Our ref: SSD-8445-PA-109

Subject: Tahmoor South Project (SSD-8445) LW S1A – S6A Extraction Plan – Amendment 2

Figure 1: Amendment 2 – Modified LW S4A Layout

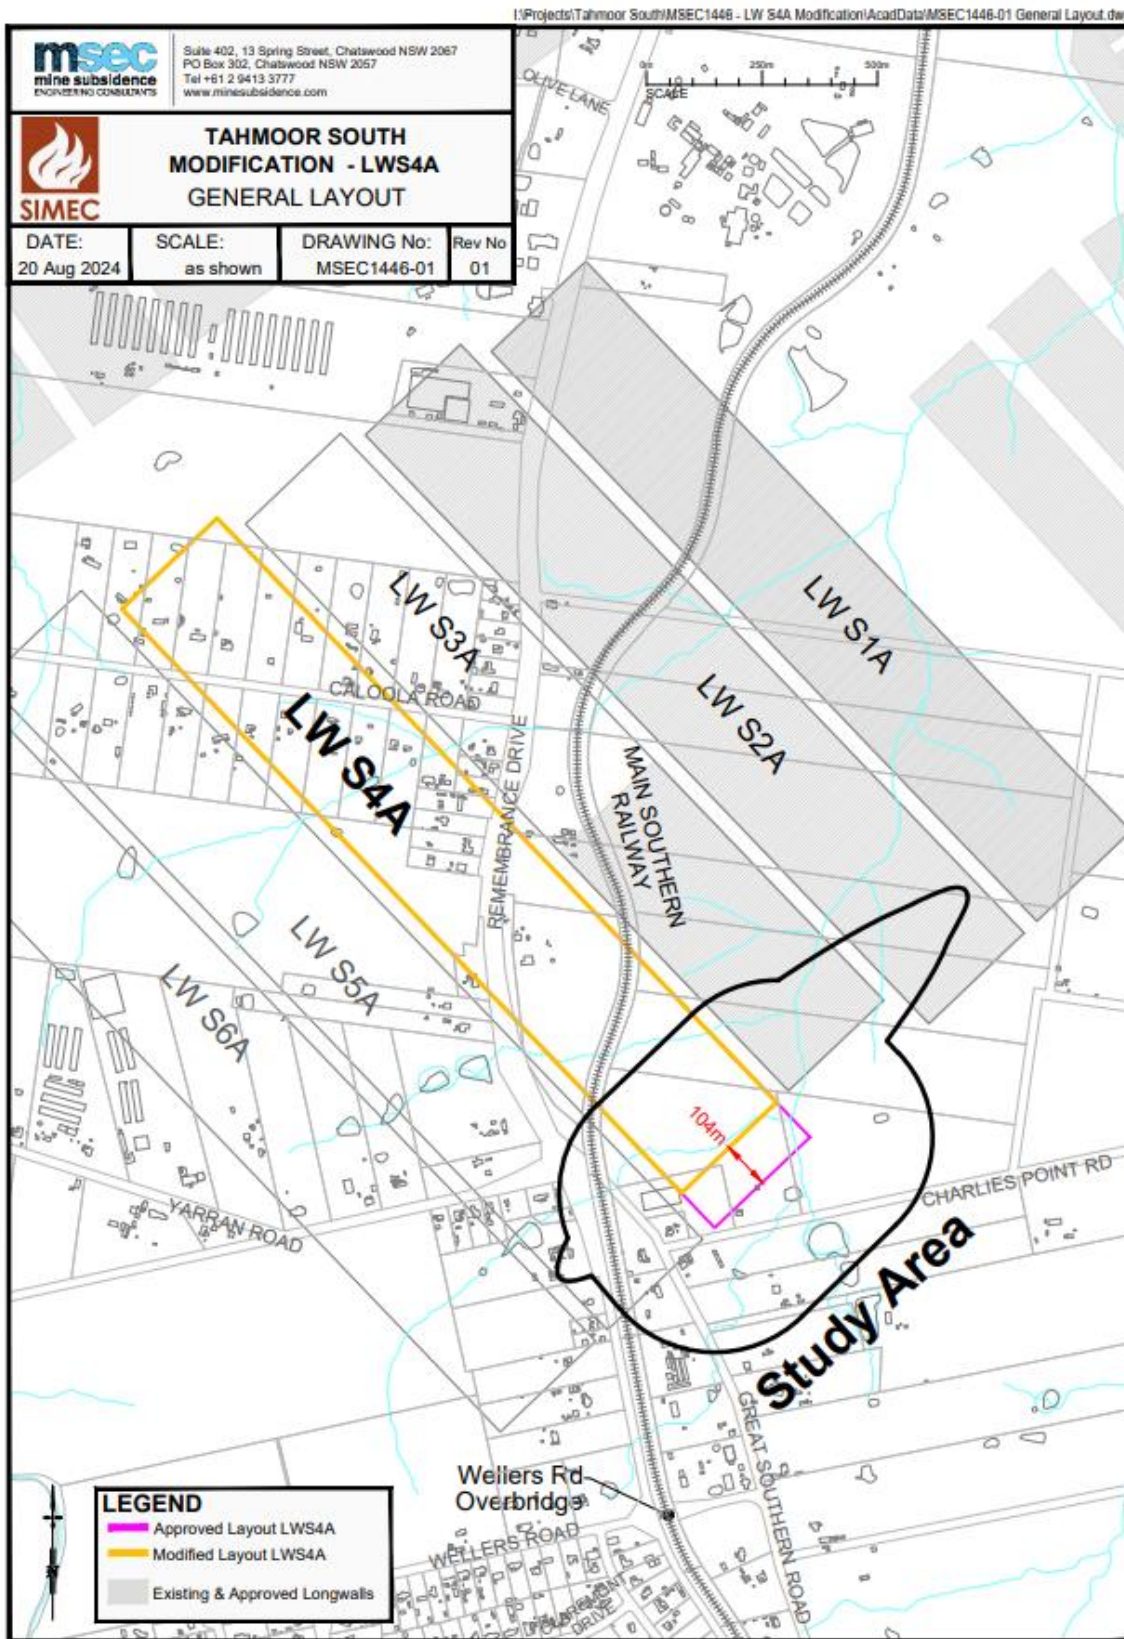
The Department notes that the amendment seeks to shorten the commencing end of LW S4A by 104 metres from the position approved in the LW S1A-S6A Extraction Plan. The modified layout of LW S4A is shown in Figure 1.

The Department has carefully reviewed your request and supporting subsidence assessment prepared by MSEC (2024) and sought advice from the Department of Regional NSW - Mining, Exploration & Geoscience. The Department is satisfied that the modified layout would result in a slight reduction in the magnitude of predicted subsidence for the natural and built features located near the commencing end of LW S4A, and that no change to the management measures outlined in the approved Extraction Plan or sub-plans is required.

- shorten the commencing end of LW S4A by 104 metres;
- incorporate the management of Pamak Hobbies and Bargo Cemetery into the existing LW S1A – S6A Built Structures Management Plan and Wollondilly Shire Council Management Plan, respectively; and
- prepare an additional management plan for the management of the Wellers Road Overbridge.
